A LEAK HAS BEEN DETECTED IN A  
STEAM GENERATOR. THIS FALLS UNDER  
ABNORMAL OCCURRENCE DEFINITION  
1.8.2. THE PROBLEM IS BEING INVESTIGATED  
BY OUR CONTRACTORS & IT HAS BEEN FOUND  
THAT THE LEAK IS DUE TO CRACKING  
OF THE TUBE SEAL WELDS AT THE TUBE  
SHEET DUE TO A SEPARATION OF THE INCLAD  
CLADDING FROM THE TUBE SHEET. THIS  
SEPARATION HAS BEEN FOUND IN TWO

In reference to Report No. DC 89, "Inspection of Leaks and Cracks in the (A) Steam Generator at H. B. Robinson II," June 23, 1971, I would like to offer the following opinions and recommendations:

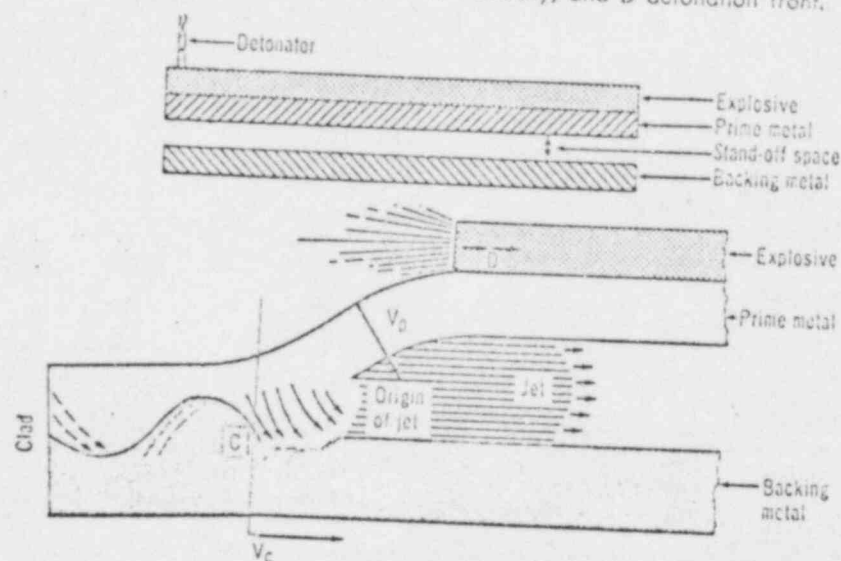
- (1) Westinghouse is primarily placing the blame for this leakage and cracking problem on the inadequacy and reliability problems associated with the explosion bonding cladding process. There is justification in placing high suspicion on this process. Experience has indicated that inconsistent bond integrity has been obtained on large, relatively complicated parts. For example, bond adhesion problems might be expected to localize in the central and outer edge portions of a component such as the steam generator. Although the basic principles and potential of this process have merit, the application of the process to various components often presents considerable practical difficulties.

The process dates back to the late 1950's and early 1960's and, is generally based on the Cowan, G. R., Douglass, J. J., and Holtzman, A. H., U. S. Patent No. 3,137,937 issued June 3, 1964 and assigned to E. I. du Pont de Nemours and Co. A typical cladding arrangement, as well as the basic operating principles are illustrated in Figure 1. After the explosive is detonated, the prime metal is accelerated very rapidly to a high velocity ( $V_p$ ) by the detonation pressure. As the detonation front (D) moves across the plate, an angle is established between its undeflected and deflected portions. When the deflected portion of the prime metal collides with the backer plate, the region of high-pressure collision moves across the plates at high speed. This velocity ( $V_c$ ) equals the detonation

velocity for the illustrated situation. Ahead of the collision region in each plate, high pressures cause surfaces of both metals to flow plastically into the space between the plates.

The jet which forms acts to remove surface films of oxides and of other materials normally detrimental to bonding. At the same time, the clean metal surfaces are subjected to high pressures in the collision region causing plastic deformation. The metals supposedly come into interatomic contact with each other, establishing a metallurgical bond.

Based on this failure and past experiences of manufacturers of large vessels, it is recommended that past and intended future application of this process be thoroughly reviewed.
